Re: EQ#24-2665 Seventh Day Adventist Subdivision Review  
EQ#24-2506 Seventh Day Adventist Public Wastewater Review  
EQ#24-2444 Seventh Day Adventist Public Water System Review

This letter is in response to your review letter for the subdivision, public wastewater, and public water review. Below you will find individual responses to each of your presented deficiencies. Attached you can find supporting materials with the requested updates.

SITE LAYOUT

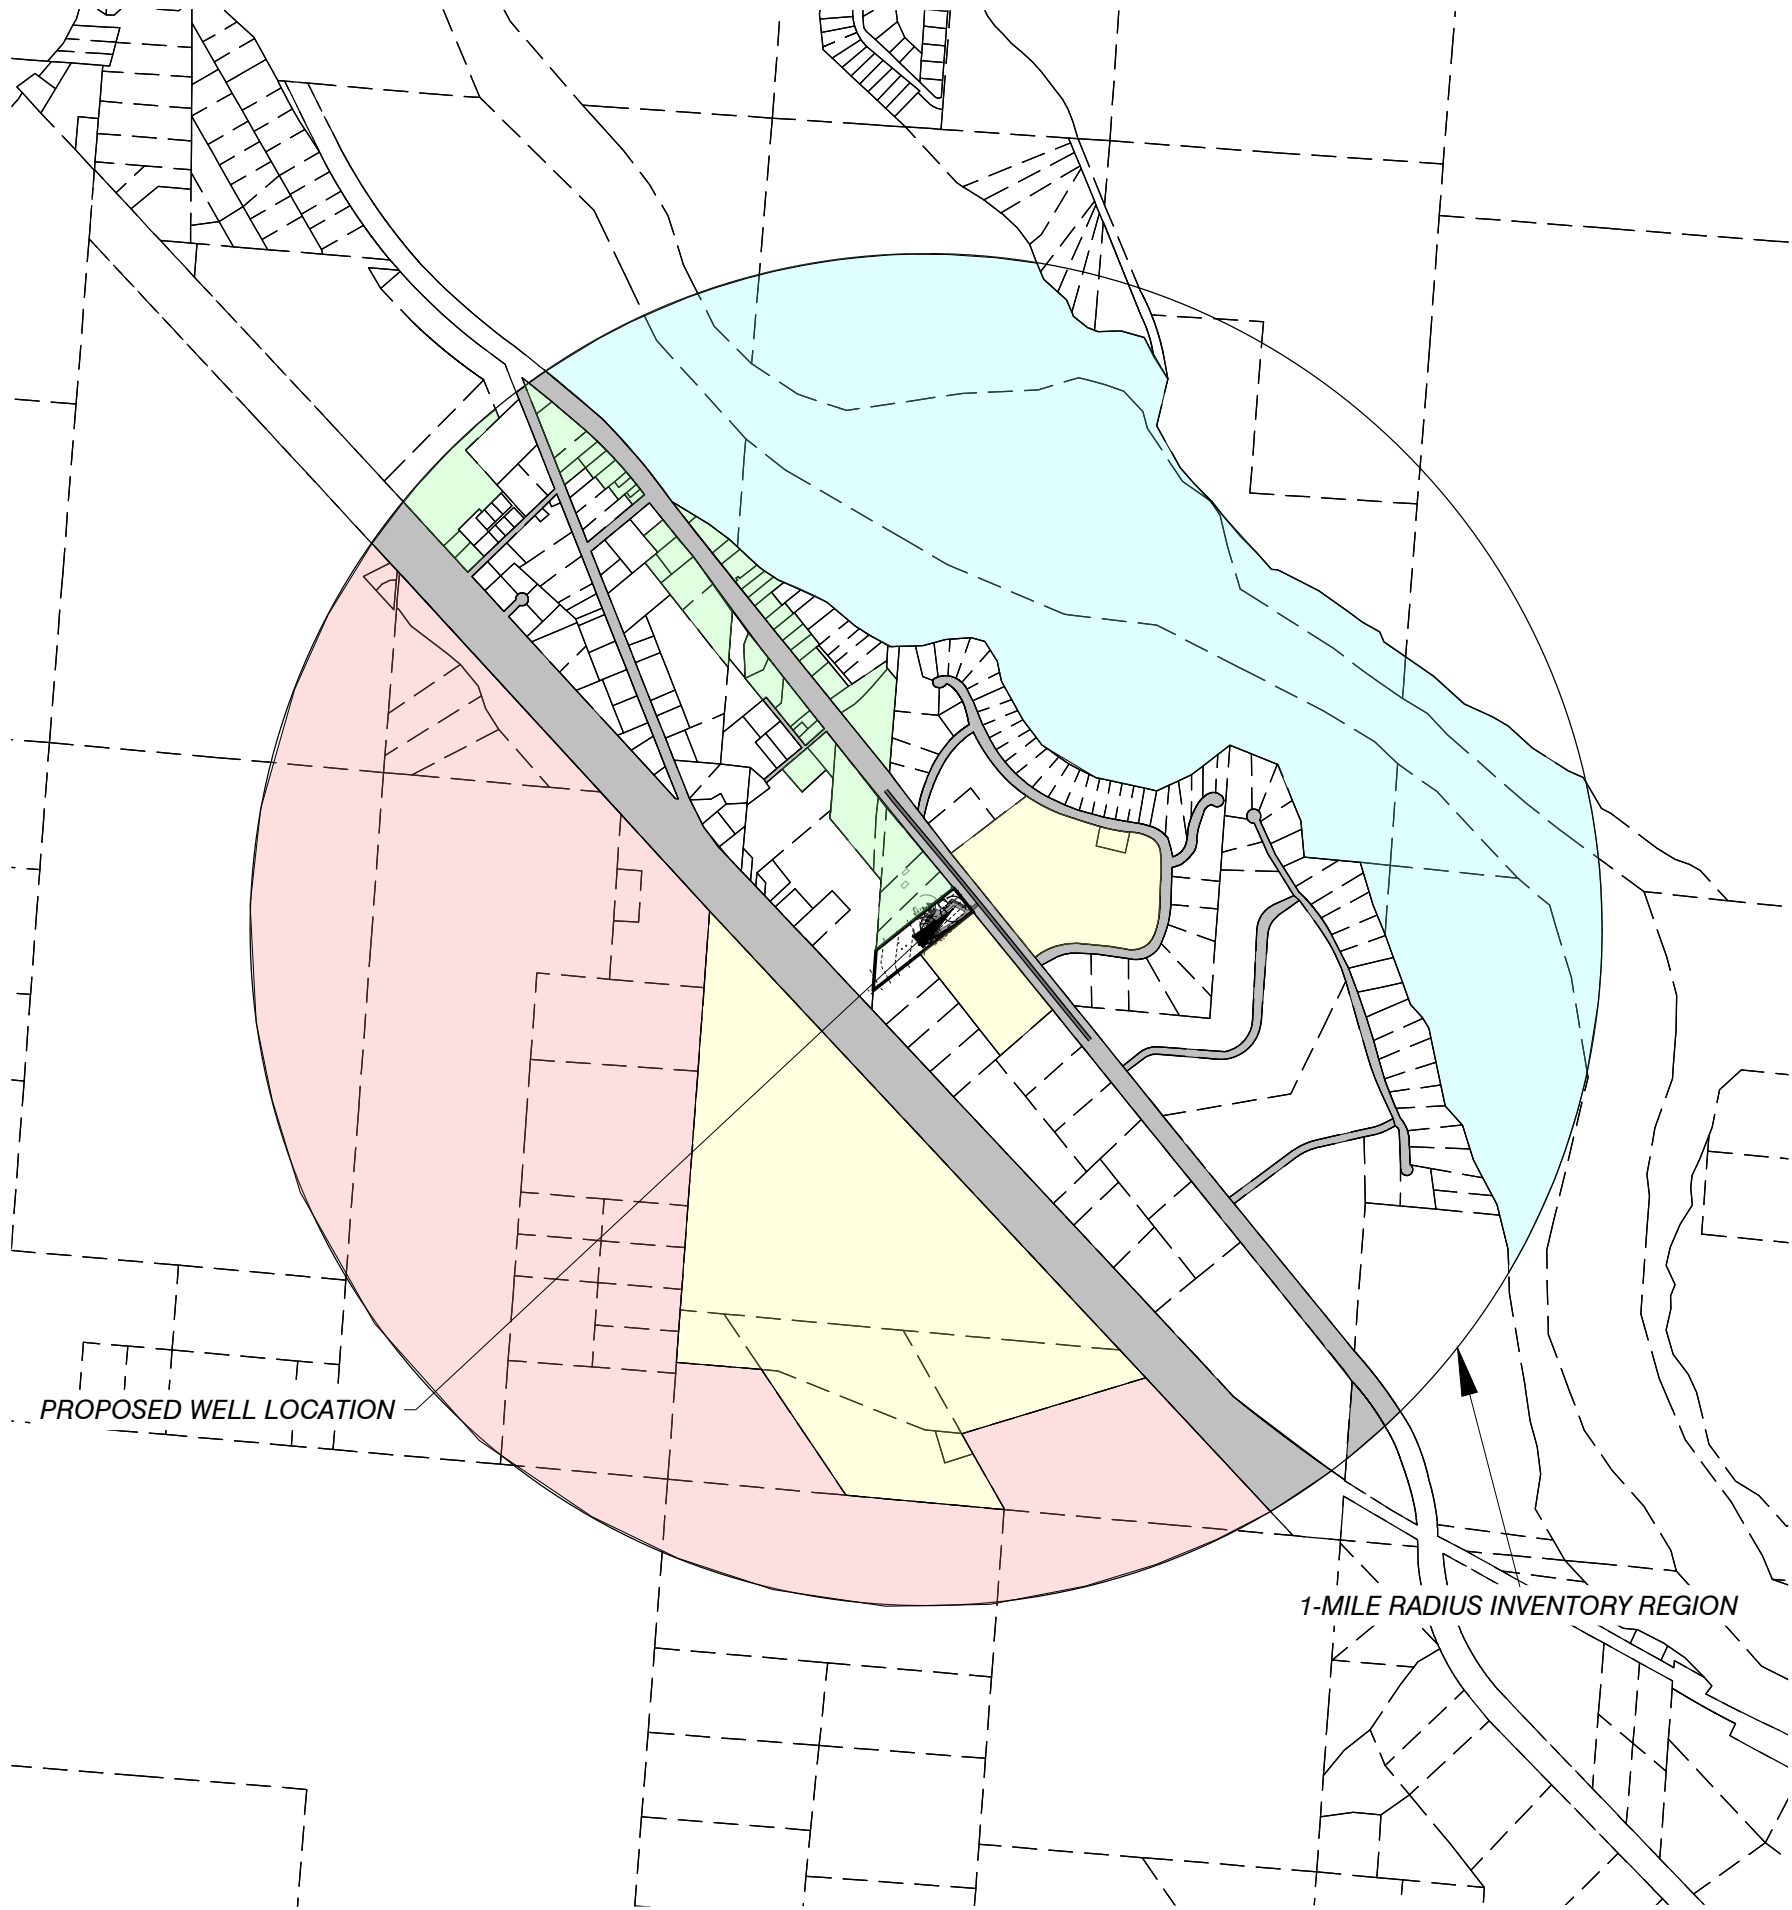
7. There are no stormwater facilities shown on the public water site layout sheet 1, DEQ - 3, Standard 1.1.6.d, Standard 1.2.2.d.

- *See updated stormwater details.*
